Access Compliance Report

Public Rights-of-Way (Curb Ramps)

Intersection ID: 52622	Main Street: HERITAGE_POND_DR	Cross Street: ALEXANDER_COMMONS_DR	Location:	N
ADA ID: 87FB90911479	Ramp Type: Perp	Initial Pass/Fail: Fail	Overall Compliance: No	Severity Score: 12.5
Codes/Mitigation Info/Possible Solution		Field Measurements/Component Compliance

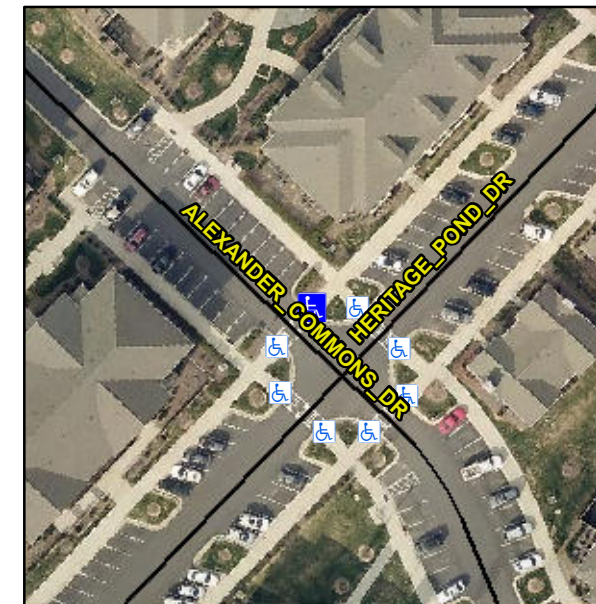
R304.2.2

Compliance	Description	Data	Compliance	Description	Data
N/A	Ramp Length (in)	98.0	No	Ramp Slope (%)	9.6
Yes	Ramp Width (in)	95.0	Yes	Ramp XSlope (%)	1.5
N/A	Flare Type LT	N/A	N/A	Flare Type RT	N/A
N/A	Flare Slope LT (%)	N/A	N/A	Flare Slope RT (%)	N/A
N/A	Flare Traversable LT?	N/A	N/A	Flare Traversable RT?	N/A
N/A	Landing Length (in)	N/A	N/A	DWS Provided?	N/A
N/A	Landing Width (in)	N/A	N/A	DWS Contrast?	N/A
N/A	Landing Slope (%)	N/A	N/A	DWS Length (in)	N/A
N/A	Landing X Slope (%)	N/A	N/A	DWS Full Width?	N/A
N/A	Landing Curb? (Y/N)	N/A	N/A	DWS Offset (in)	N/A
N/A	Shared Landing?	N/A			
N/A	Gutter Ponding?	N/A	N/A	Gutter Slope (%)	N/A
N/A	Gutter Lip Ht (in)	N/A	N/A	Gutter X Slope (%)	N/A
N/A	Painted X Walk1?	Yes	N/A	Painted X Walk2?	N/A
	X Walk 1 Direction	To SW		X Walk 2 Direction	N/A
N/A	X Walk 1 Width (in)	89.0	N/A	X Walk 2 Width (in)	N/A
	X Walk 1 Slope (%)	0.8		X Walk 2 Slope (%)	N/A
	X Walk 1 X Slope (%)	1.0		X Walk 2 X Slope (%)	N/A

Remove & Replace Entire Ramp.
